**RE: Albuquerque School of Excellence  
13201 Lomas Blvd. NE  
Revised Grading & Drainage Plan  
Engineer's Stamp Date: 07/20/20  
Hydrology File: J22D050**

RE: **ALBUQUERQUE SCHOOL OF EXCELLENCE  
13201 LOMAS BLVD NE  
REVISED GRADING & DRAINAGE PLAN  
ENGINEER'S STAMP DATE: 07/02/20  
HYDROLOGY FILE: J22D050**

<b>ABQ SCHOOL OF EXCELLENCE</b> <b>OVERALL GRADING AND DRAINAGE PLAN</b>	DRAWN BY pm DATE 7-20-2020 DRAWING 2019068-GR SHEET # <b>GR-1</b> JOB # 2019068
	ENGINEER'S SEAL RONALD R. BOHANNAN NEW MEXICO PROFESSIONAL ENGINEER 7868 7-20-2020 RONALD R. BOHANNAN P.E. #7868	TIERRA WEST, LLC 5571 MIDWAY PARK PL. NE ALBUQUERQUE, NEW MEXICO 87109 (505) 858-3100 www.tierrawestllc.com

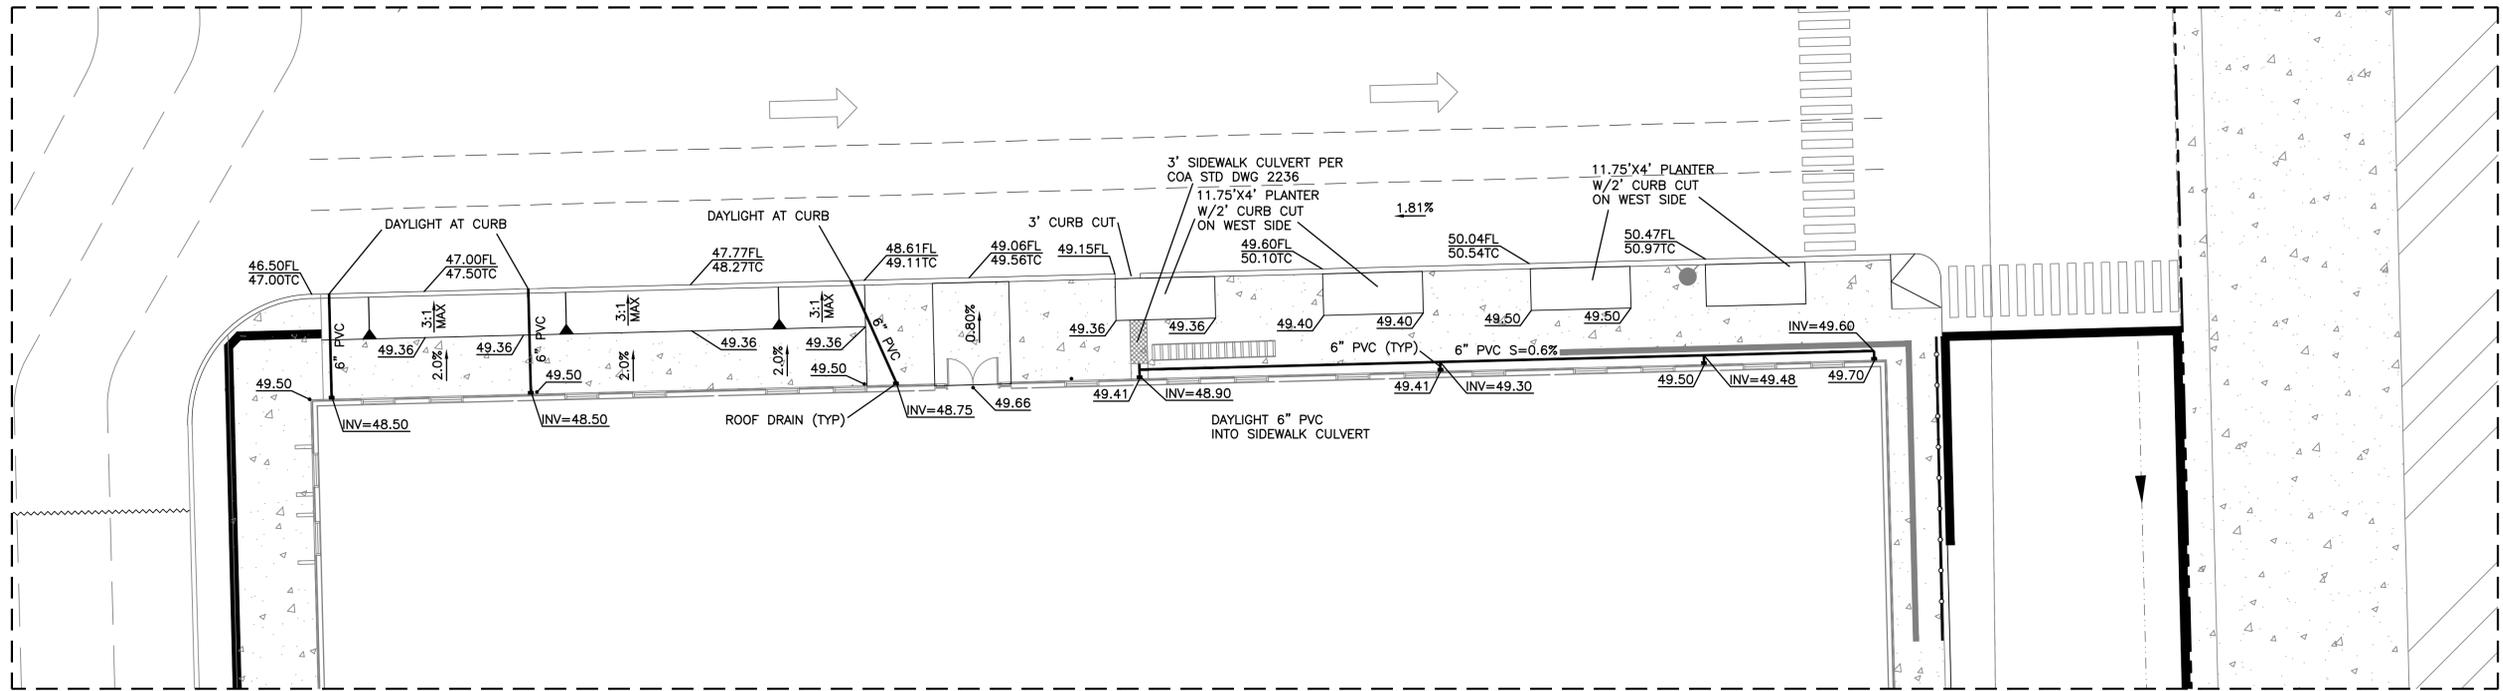
1. Sheet GR-1 almost all the line work is the same line weight, so I can't tell what existing items are and what proposed items are. Please correct the proposed items with a darker line weight. **The proposed revisions are to the entire parking lot area. The line work was darkened up to help illustrate the new improvements and the area was bubbled.**

2. Sheet GR-1 this goes with the first comment. Are all the paving new or is there going to be paving that is to remain? If there is paving to remain, then there needs to be a break line. **The entire parking area will be repaved.**

3. Sheet GR-1 it is hard to tell where Pond A and Pond B are located. Please provide a top of pond outline (contour) and a bottom of pond outline (contour) **The Ponds are now shown with darker lines and called out with notes.**

4. Sheet GR-1 please provide an emergency spillway for both retention ponds by way of sidewalk culverts. The elevation of the sidewalk culverts should be the 100 year – 10 day WSE. **A sidewalk culvert was added to Pond "A" that daylights to Lomas and a 2' curb opening was provided to Pond "B" that daylights to the drive aisle. Both are sized to handle the 100 year flow.**

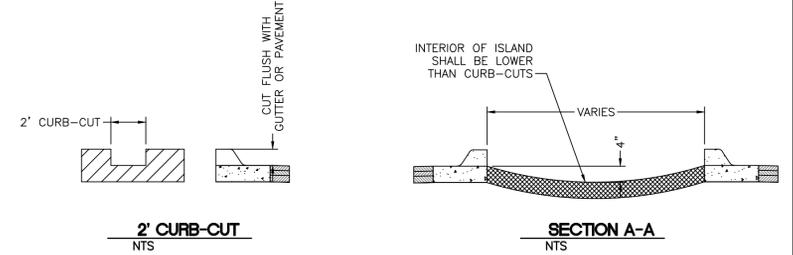
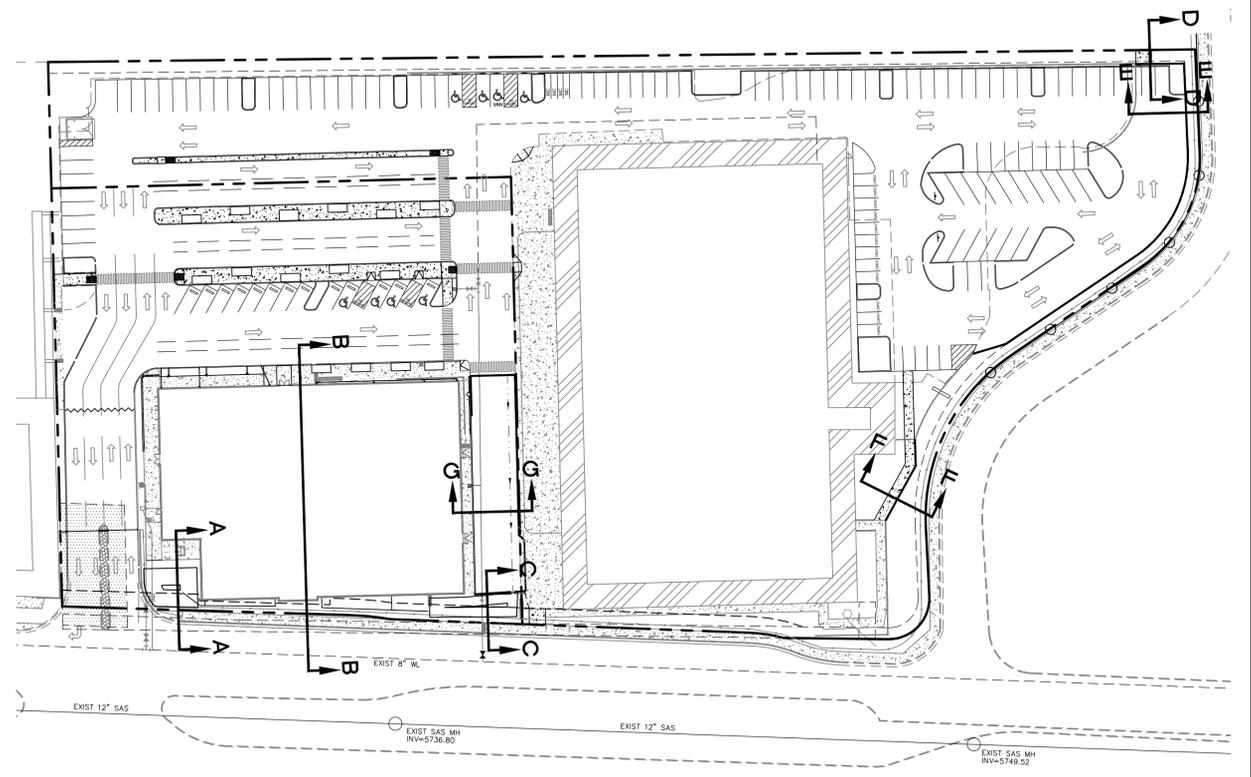
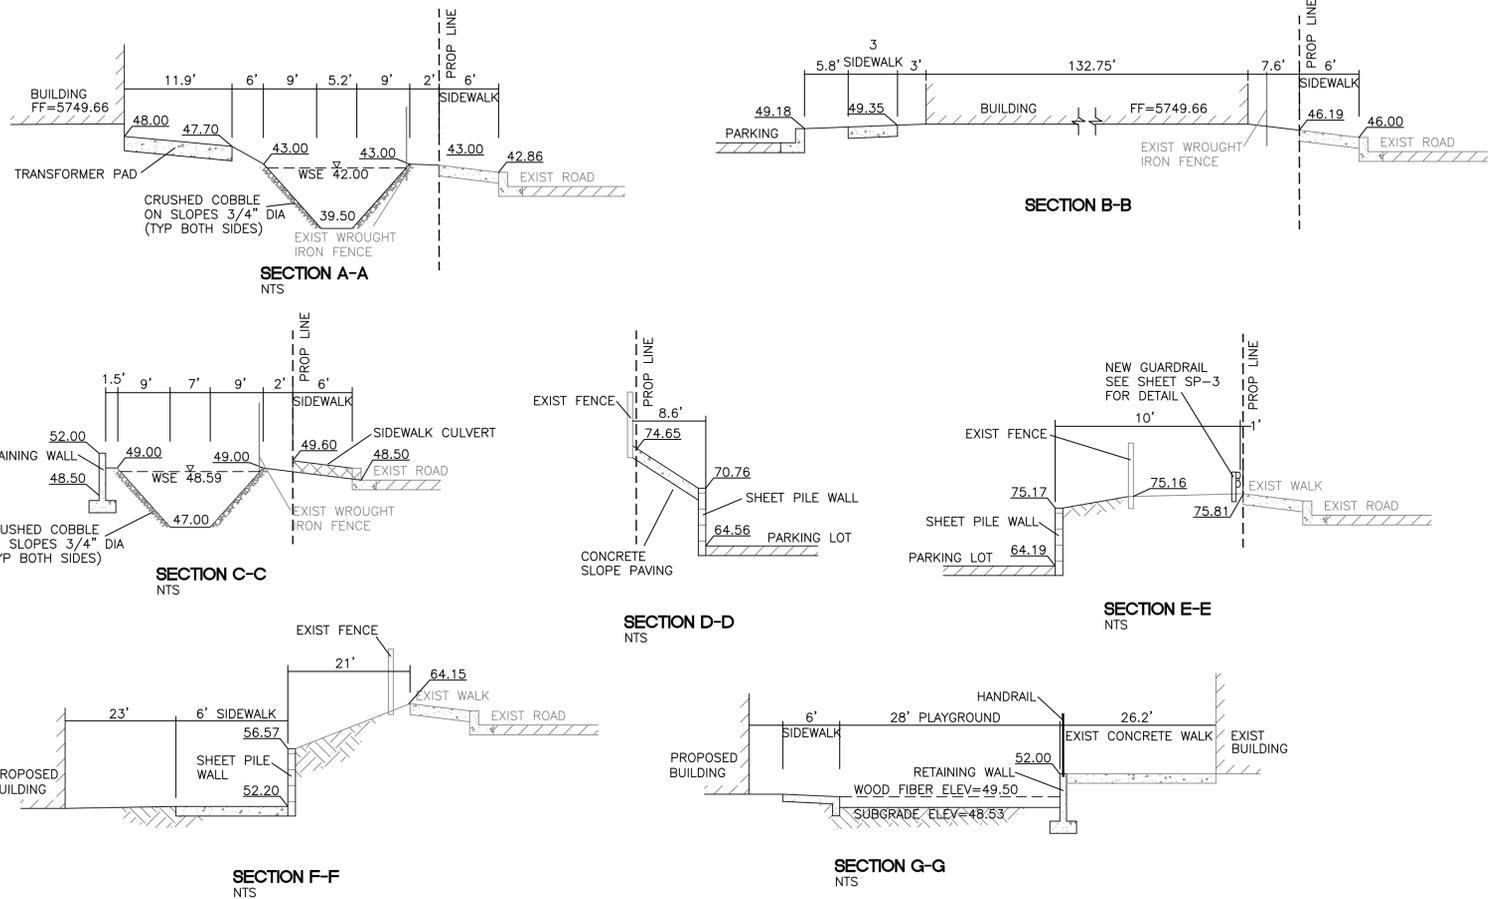
5. Sheet GR-1 please us the latest SO-19 notes (see attachment) **The latest SO-19 note was added to the plan.**
6. Sheet GR-2 all sections please correct the location of the Property Line / ROW. This is shown correctly on Sheet GR-1. Within the ROW should be the sidewalk (at the ROW line) the curb and the roadway. **All of the cross sections were updated and corrected.**

7. Sheet GR-2 sections A-A & C-C please show the emergency spillway (sidewalk culvert) **The emergency spillways were added to the cross-sections.**
8. Sheet GR-2 sections G-G one of the buildings should be labeled as proposed. Please correct. **The building labeling was changed as requested.**
